Memorandum

From: Eric Hildebrandt, Executive Director, Market Monitoring

Date: February 3, 2022

Re: **DMM comments on resource sufficiency evaluation enhancements**

**Figure 1. Impact of including uncertainty in upward capacity test
June to December, 2021**

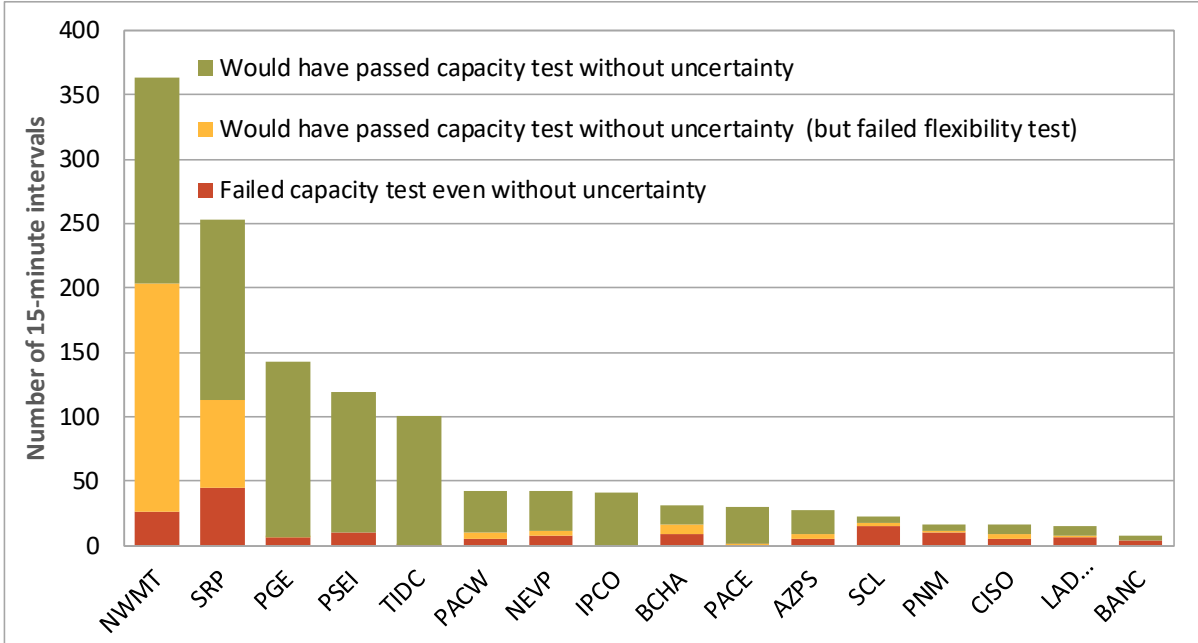
Excluding the uncertainty component from the capacity requirement would significantly decrease the number of intervals that balancing areas fail the capacity test and have EIM transfers limited. Figures 1 and 2 show the impact that excluding the net load and inertia uncertainty components would have on the upward capacity test during the period from when the uncertainty was added to the requirement in June 2021 through December 2021.

Figure 1 shows these results in terms of the total number of 15-minute intervals each balancing area would have failed the test with and without the uncertainty component from June to December 2021. Figure 2 shows these results in terms of the percentage reduction in test failures that would have resulted in each balancing area with removal of the uncertainty component over this period.

**Figure 3. California ISO — July 9, 2021
(CAISO hit a stage 2 emergency, Third highest load day of the year)**

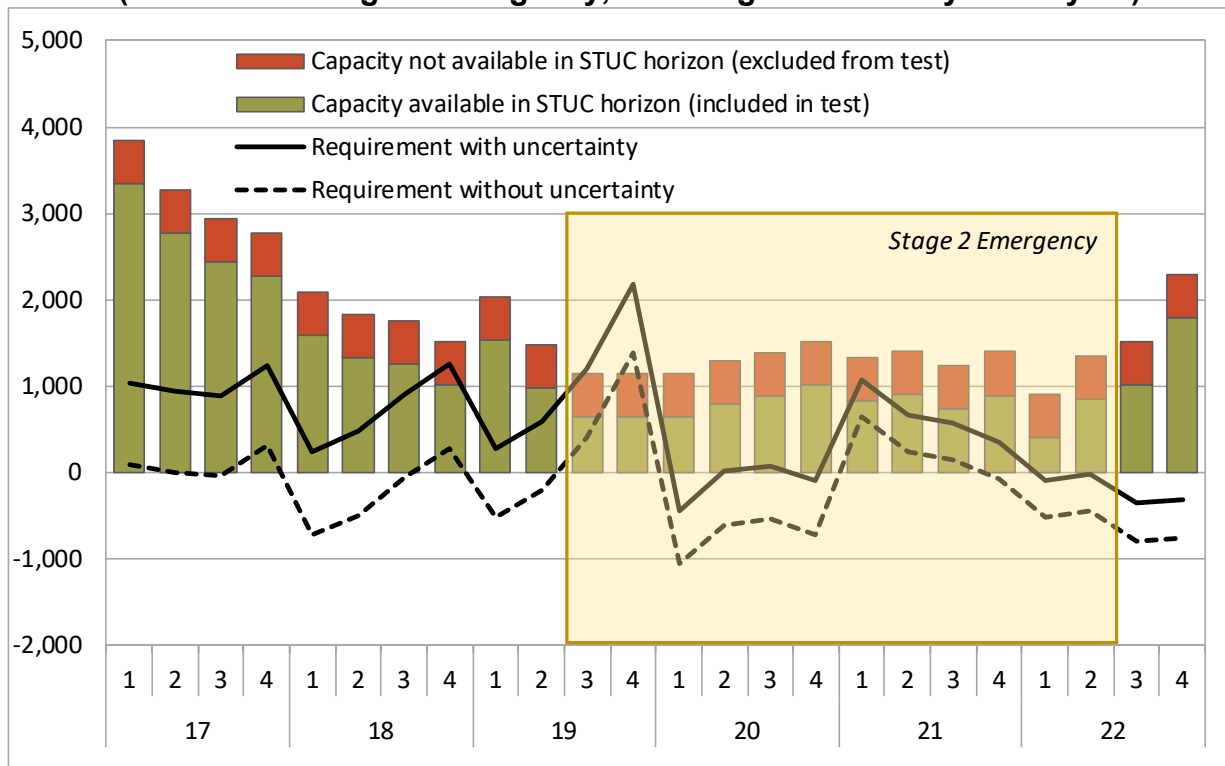
Figure 3 shows results for the CAISO balancing area on July 9, 2021. On this day, there was about 500 MW of capacity that would-have-been excluded in each interval under the proposal. This is because of a single extremely long-start unit that went on outage in the morning and was not able to return in any STUC horizon during the peak load hours.

As shown in Figures 3 through 5, removing the uncertainty requirement would have reduced the number of intervals in which the ISO area failed the test on July 9 and September 8, but would not have had any impact on September 9.

**Figure 4. California ISO - September 8, 2021
(Highest load day of the year)**

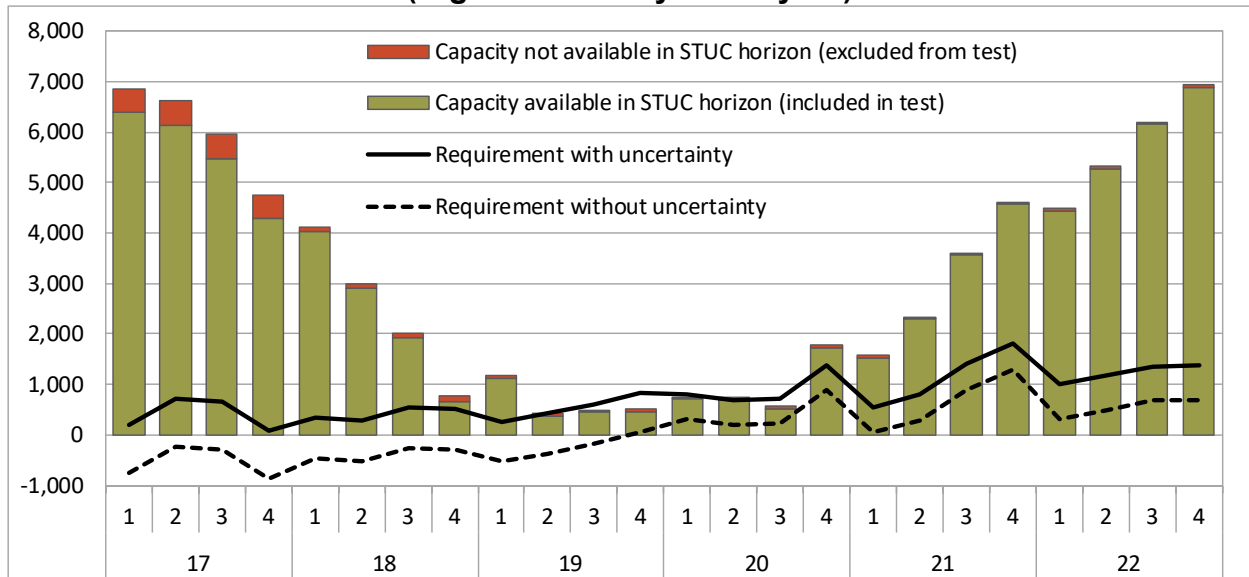
Figures 4 and 5 show results for the CAISO balancing area for September 8 and 9, 2021, which represent the first and second highest load days of the year, respectively. For each of these days, just under 500 MW of off-line capacity would be excluded in HE17, but otherwise the proposal had little impact on available capacity during the other highest net-load hours. In HE17, the excluded capacity was associated with long-start resources, which was scheduled for the highest load hours, but could not be committed in STUC horizon for HE17.
